Docket Number:	08-AFC-08A
Project Title:	Hydrogen Energy Center Application for Certification Amendment
TN #:	200131
Document Title:	AIR Traffic Study Questions and Comments
Description:	N/A
Filer:	Tiffani Winter
Organization:	Association of Irritated Residents
Submitter Role:	Intervener
Submission Date:	8/8/2013 2:14:31 PM
Docketed Date:	8/8/2013

Aug 7, 2013 **AIR Traffic Study Questions and Comments**

Re: Traffic Study Technical Memorandum (Revision 2) submitted by HECA on August 1, 2013 questions.

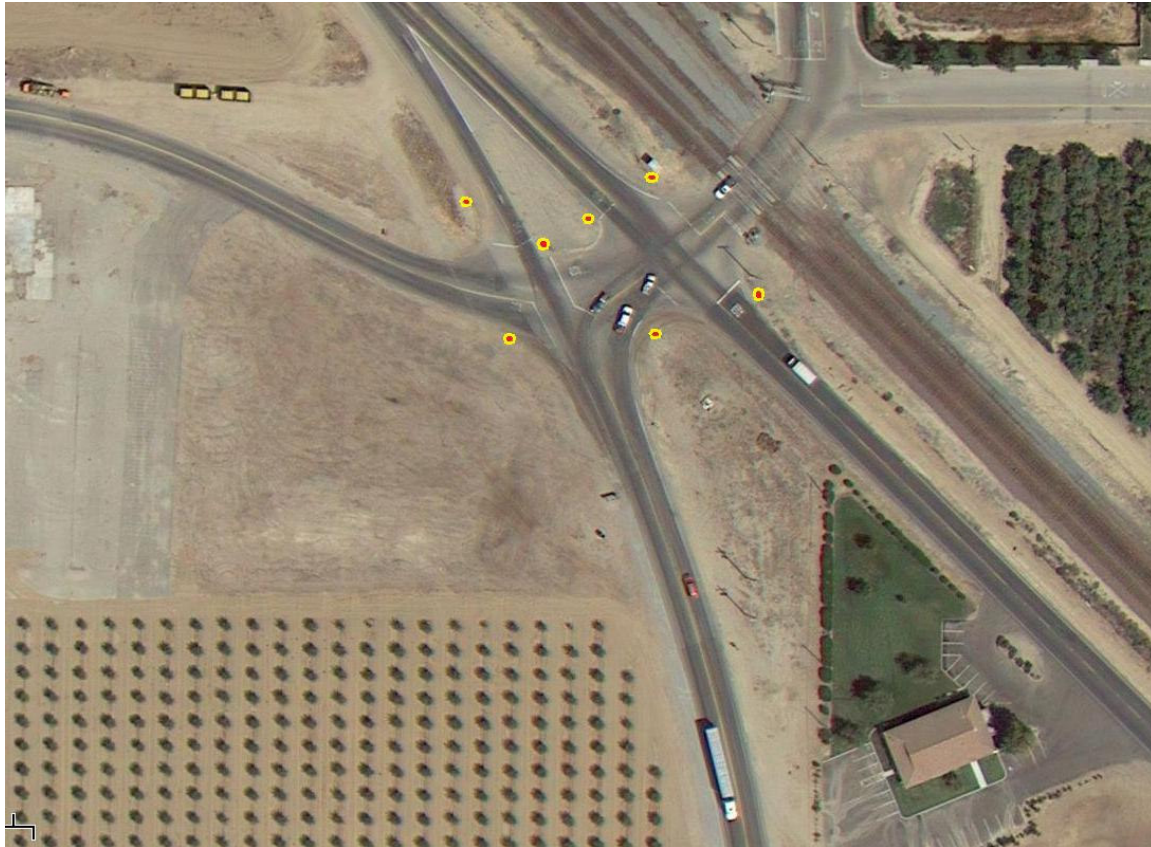
The area in question is along Hwy 43 at the intersections of Los Angeles Ave, Beech, and Santa Fe Way. This is essentially a very busy 5 or 6-way intersection with 7 stop signs and really tight turns for any traffic traveling north on Hwy 43 which would be the case for the empty coal trucks returning to Wasco.

HECA needs to complete their study by analyzing the traffic flow, turns, safety, and road surface conditions at this intersection. It seems obvious that mitigation of this intersection will be needed. AIR suggests an overpass, traffic lights and more gradual turning radii would all be appropriate mitigations.

Below is a photo of the intersection from Google Maps. Please observe the length of the truck at the bottom of the photo in relation to this intersection. The seven stop signs are indicated with yellow and red dots inserted into the photo. We will also note that the building on the lower right is a medical center for patients. Many patients with breathing difficulties will be visiting this place on a daily basis and suffer from the added diesel exhaust and fine particulates coming from the coal trucks and the coal trains.

One dangerous aspect of this intersection is that northbound vehicles turning left from Hwy 43 onto Los Angeles Ave. do not have a stop sign. Another complicating factor is the railroad crossing immediately adjacent with yet another intersection and two roads approaching from just over the tracks to the east. Trains often slow in this area because there are long sidings in both directions which allow trains to pass each other. This backs up traffic at the stop signs surrounding this complicated intersection. The coal trains will definitely be responsible for backing up traffic in this area so that fact should be considered as well in this traffic study.
